SERVICE TIPS

82-16

GAME: POWER SUPPLY #08-00007-001 USED ON "QIX", ALPINE SKI, WILD WESTERN,
KRAM, ELECTRIC YO YO.

SUBJECT: BR1 AND BR2 HEATING UP TO THE EXTENT OF BREAKING DOWN INTERNALLY.

FIGURE 1

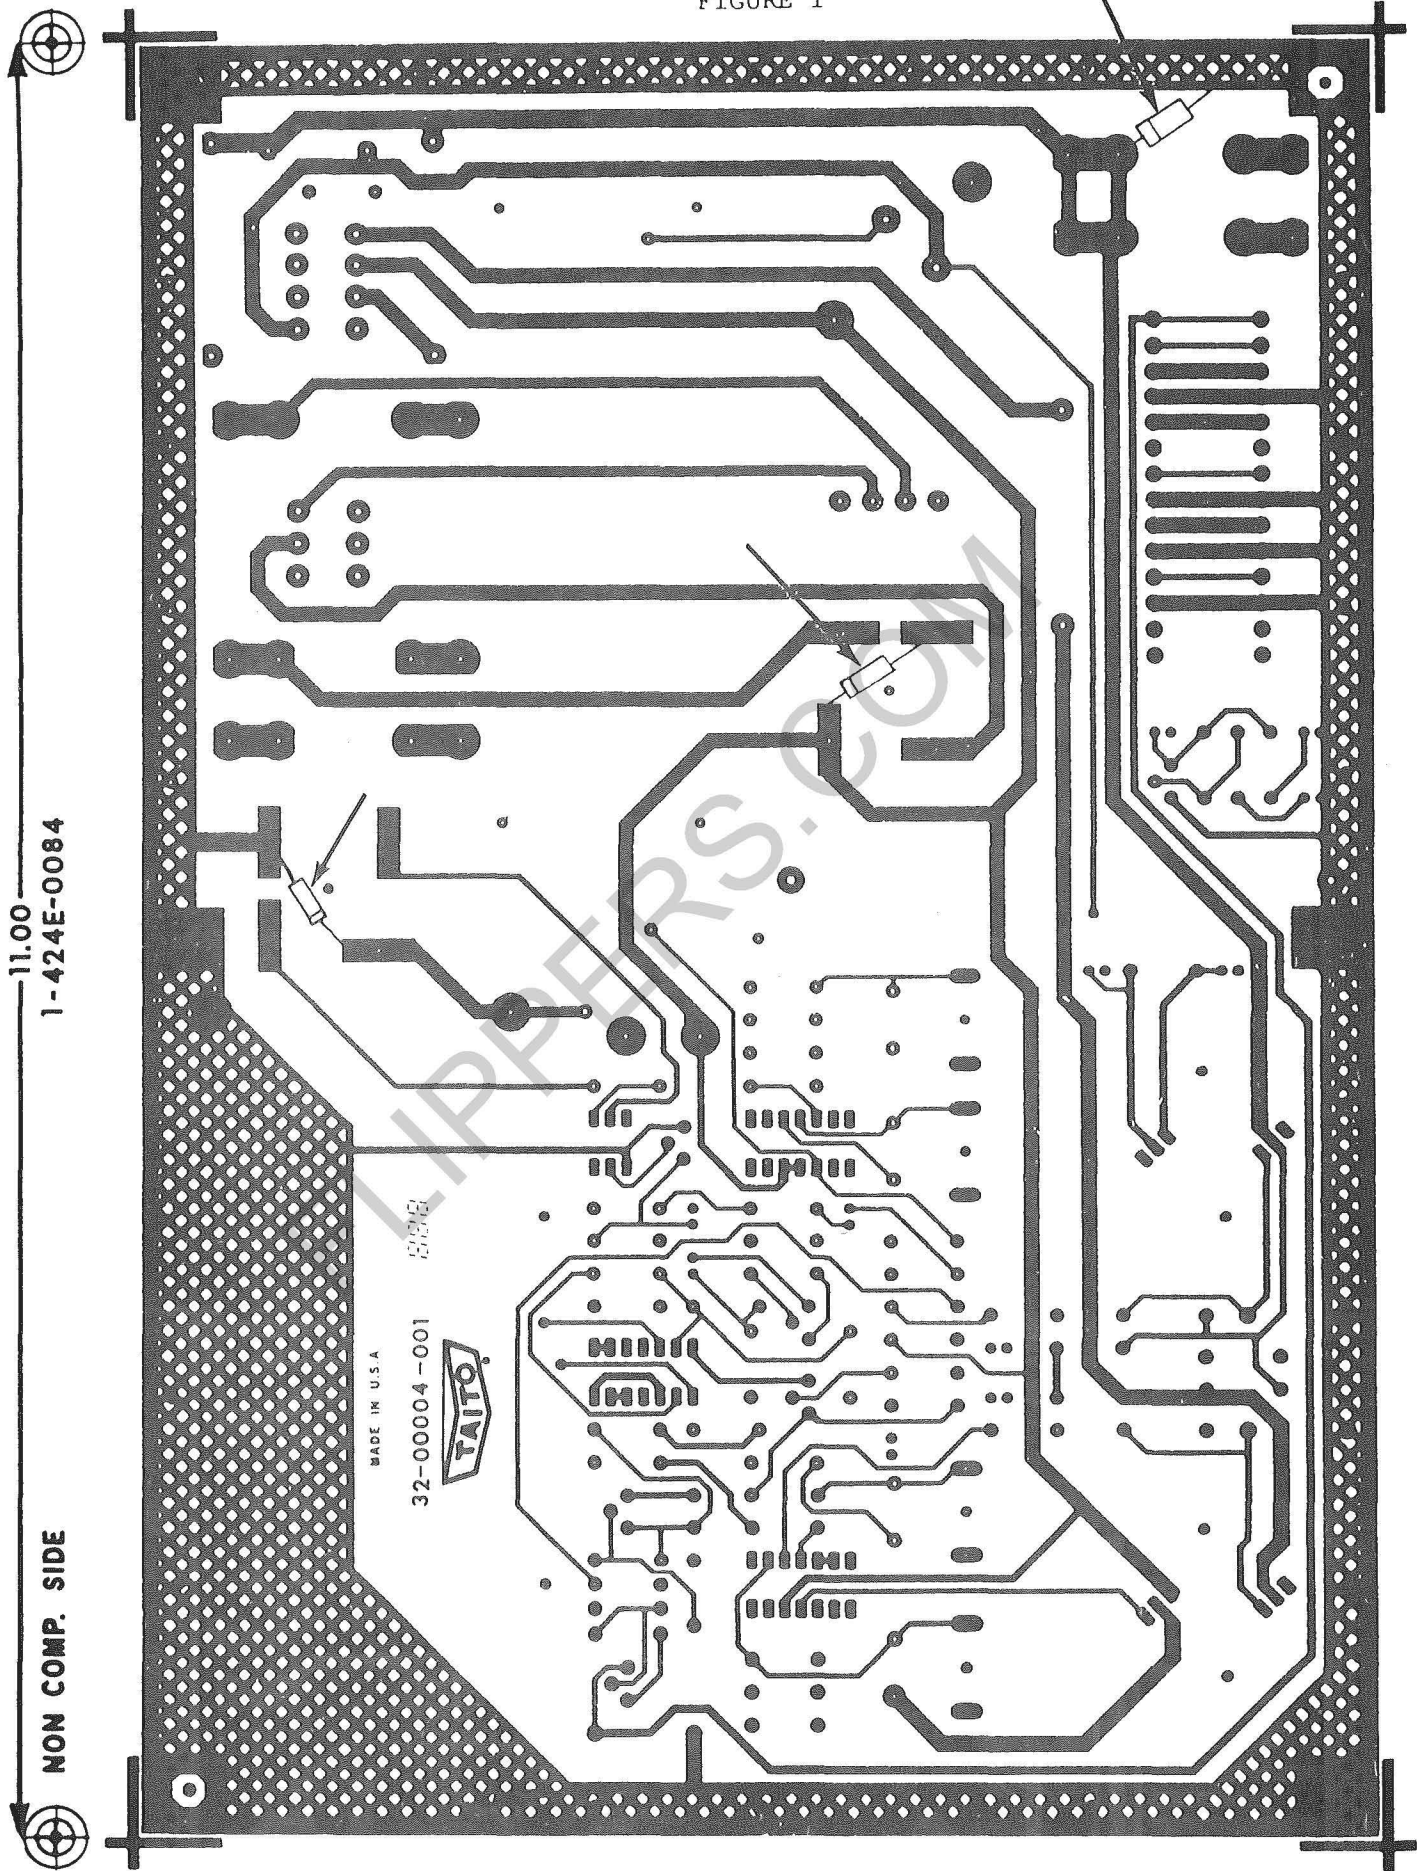
THERE ARE COMPONENTS UNDER THE POWER SUPPLY THAT LOOK LIKE DIODES (REFER TO FIGURE 1 AND 2)(ON ISS. "C" OF THE POWER SUPPLY THEY ARE CALLED D13, D14, D17 AND ARE ON THE COMPONENT SIDE). THESE COMPONENTS ARE CALLED TRANSORBS. THEY ARE USED TO COMPENSATE FOR FLUCTUATING A.C. LINE VOLTAGES. MEASURING THEM OUT OF CIRCUIT, OTHER THAN CHECKING FOR SHORTS, IS USELESS. THE ONLY WAY TO TEST THEM IS TO TAKE THEM OUT OF CIRCUIT, AND THEN POWER UP THE POWER SUPPLY WITH A LOAD. IF THE VOLTAGE, AFTER ADJUSTMENT, IS CORRECT, THEN THE TRANSORB NEEDS TO BE REPLACED.
